Re: Petition No. Petition 1454 - Line Petition_Mansfield Substation

Response to CSC-001 Interrogatories dated 06/23/2021

CL&P dba Eversource Energy
Docket No. Petition 1454

MANSFIELD 12J
STATION LIGHTING - PLAN
PLAN VIEW
MANSFIELD, CT

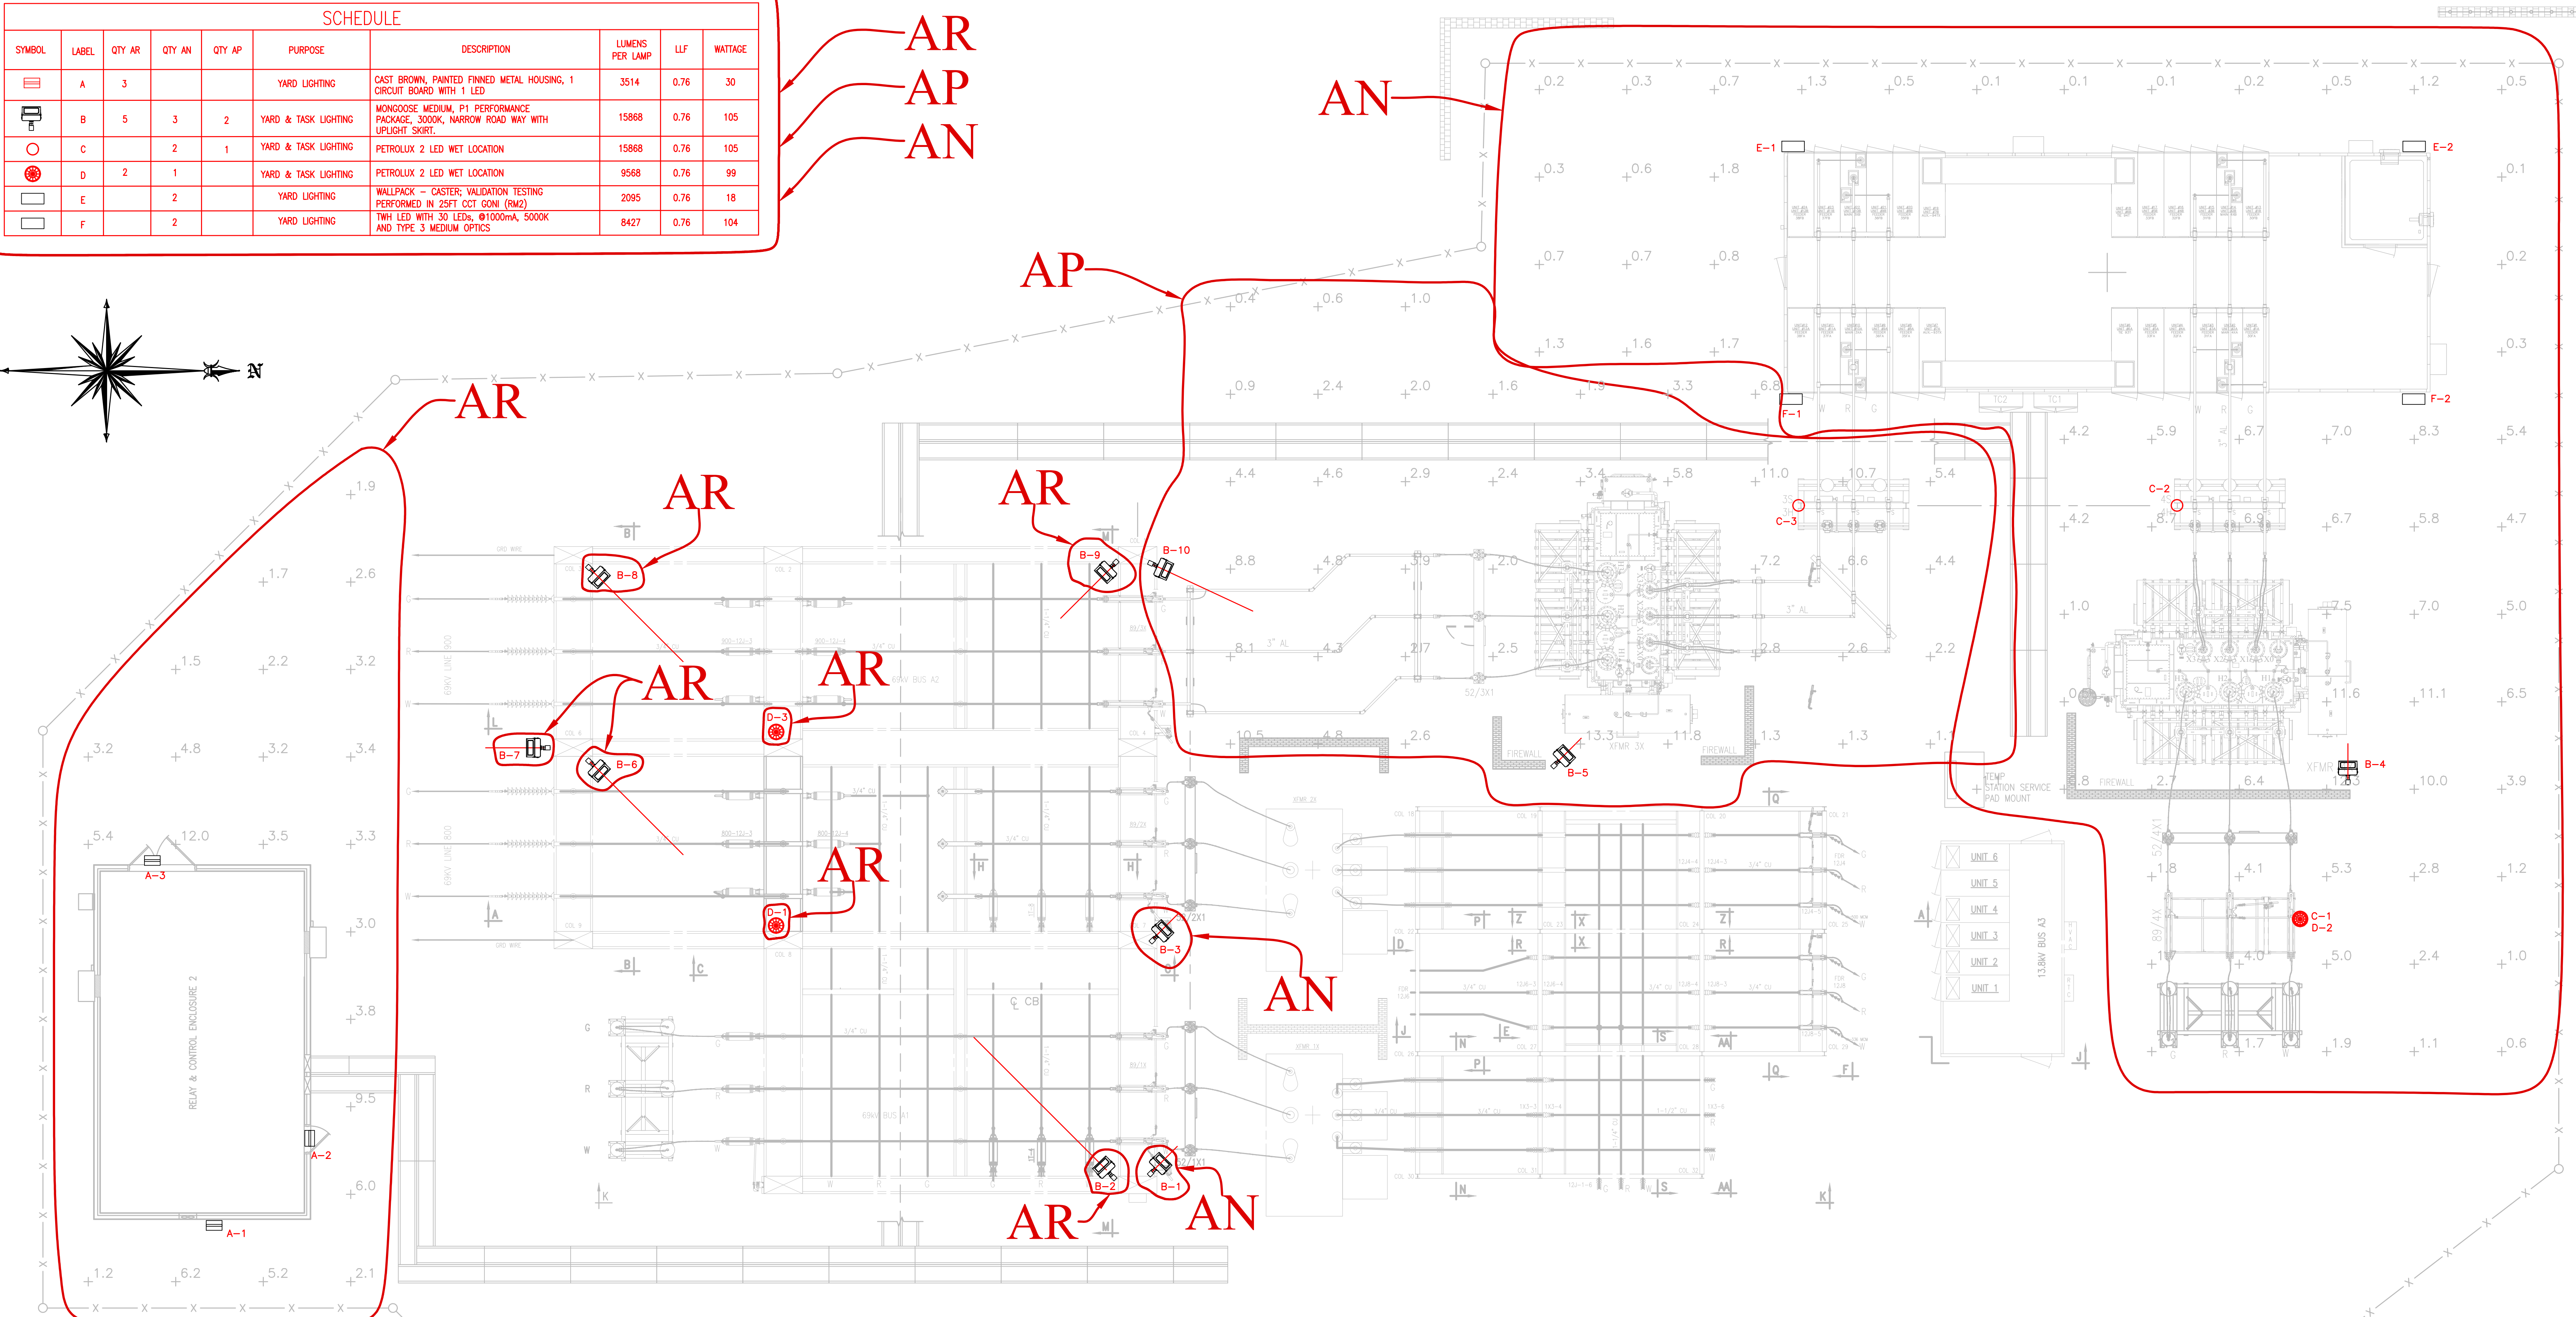
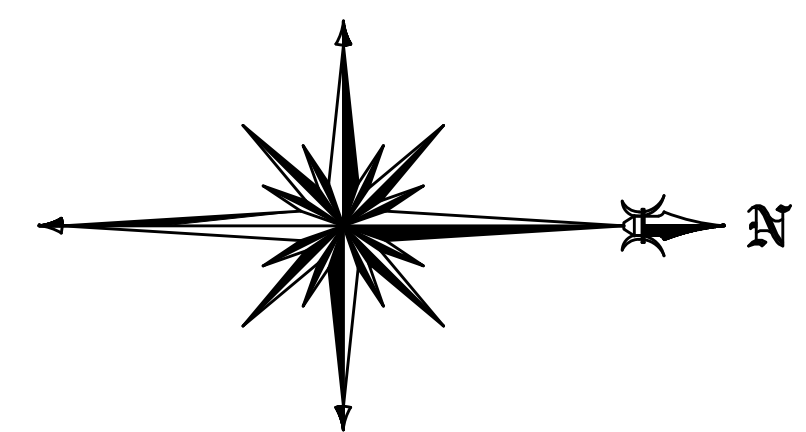
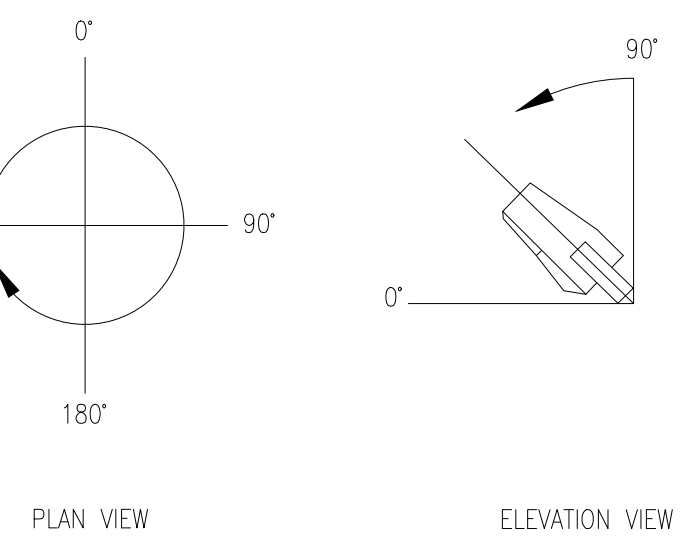
Referencing page 8 of the Petition, Eversource notes that, “The substation will use the existing lighting and install additional lighting for safety and security purposes.” What type(s) of lighting would be installed, and where on the substation footprint would the lighting be installed?

The additional lighting would be switched-controlled. Dusk to dawn lighting would have a switch to turn the lights on and off. The task lighting would be switched on during emergency and work at night. Lighting on the switchgear and the relay and control house will illuminate their access doors and surrounding area. LED lighting would be facing down for visibility when working at night and would be installed within the substation footprint as follows:

- Safety LED lighting would be mounted on relay and control house and would operate from dusk to dawn.
- Safety LED lighting on two corners of the switchgear facing the back of the switchgear and would operate from dusk to dawn.
- Safety LED lighting on two corners of the switchgear facing the front of the switchgear and would operate from dusk to dawn.
- Task LED lighting would be installed on the existing 69-kV bay structure on column 5, both fire walls facing the transformers, potential transformer structure, and the new motor-operated disconnect switch.
- Task LED lighting on the existing 69-kV bay structure on column 8 and on the new motor-operated disconnect switch.

See attachment for locations of the lighting.
